January 31, 2021

La Jolla Community Planning Association

Re: TEEL RESIDENCE Garage Accessory Structure and Companion Unit
416 Nautilus Street
Combination Building Permit - Approval No. 2216948, Project No. 621791
Coastal Development Permit, Process Two - Project No. 669815

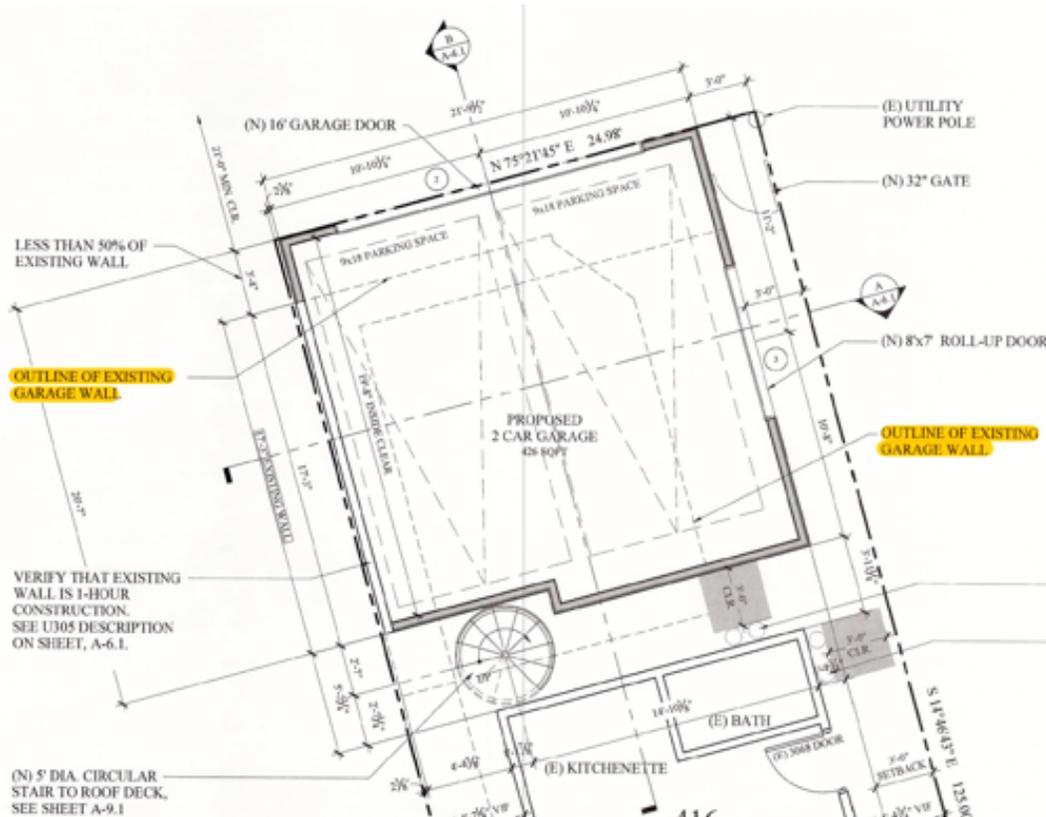
The following Floor Plan drawing from the DSD approved Building Permit Drawings (enclosed) show 72% of the exterior walls, depicted by short dashed lines, of the previous garage being as being demolished. The near total demolition of the previous garage structure required Coastal Development Permit (CDP) review and approval prior to issuance of a Building Permit to remodel the garage. This fact was either ignored or completely missed by DSD staff when they approved a Building Permit for the new garage.

But contrary to **SDMC Sec. 126.0704(a)(5)** and for exemption from CDP review and permitting, 72 percent (three of the four) of the previous garage exterior walls were completely demolished as can be seen in the photographs on the following pages.

Therefore, in accordance with **SDMC Sec. 126.0704(a)(5)**, the CDP exemption should be rescinded, all construction activity should be stopped, and the applicant should apply for a Coastal Development Permit for the garage accessory structure before any more work is allowed to continue.

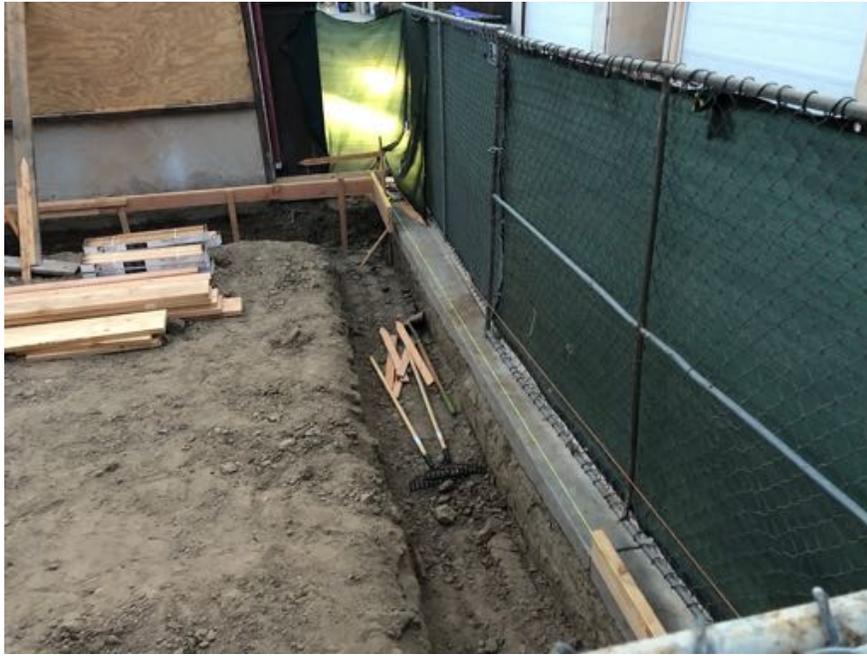
This photo is looking westward and shows the temporary construction fence along the northern property line adjacent the alley. The entire north exterior wall of the garage has been demolished. The trench is excavation for the new concrete footings for the new, yet to be constructed, north exterior garage wall with an overhead door.

II. ACCESSORY GARAGE STRUCTURE ENCROACHES INTO BOTH THE SIDE AND REAR YARDS

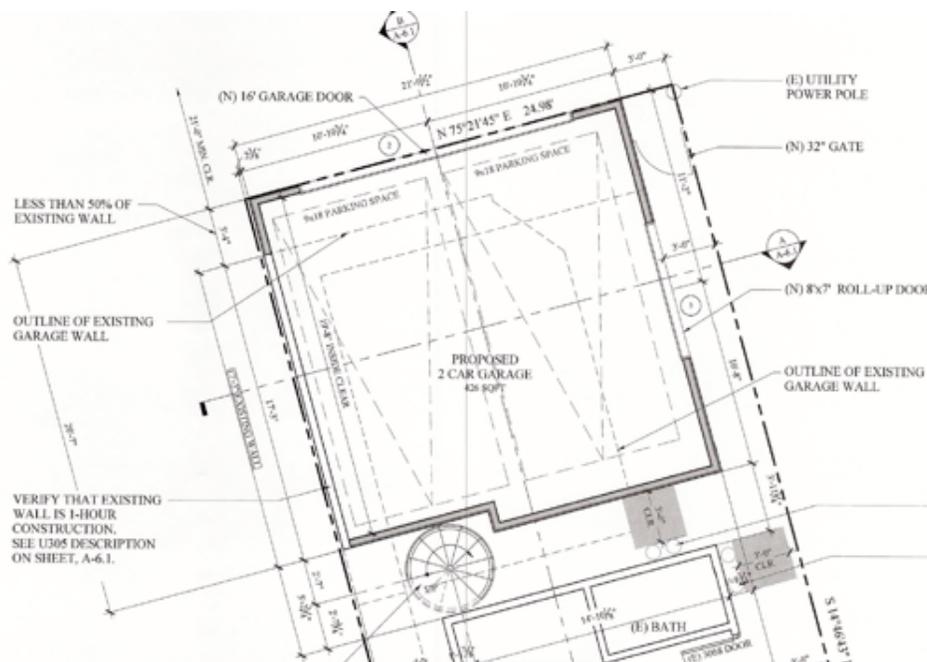
But contrary to **SDMC Sec. 131.0461(a)(12)** the new garage *accessory building* encroaches into both the interior side yard and rear yard. This fact was either ignored or completely missed by DSD staff when they approved a Building Permit for the new garage *accessory building*.

Therefore, to comply with **SDMC Section 131.0461(a)(12)**, all construction activity should be stopped, and the applicant should submit to the DSD revised drawings for a revised garage design that only encroaches into either the interior side or rear yard. To not correct the encroachments into both the side and rear yards will set a terrible legal precedent for future projects in La Jolla and throughout the City.
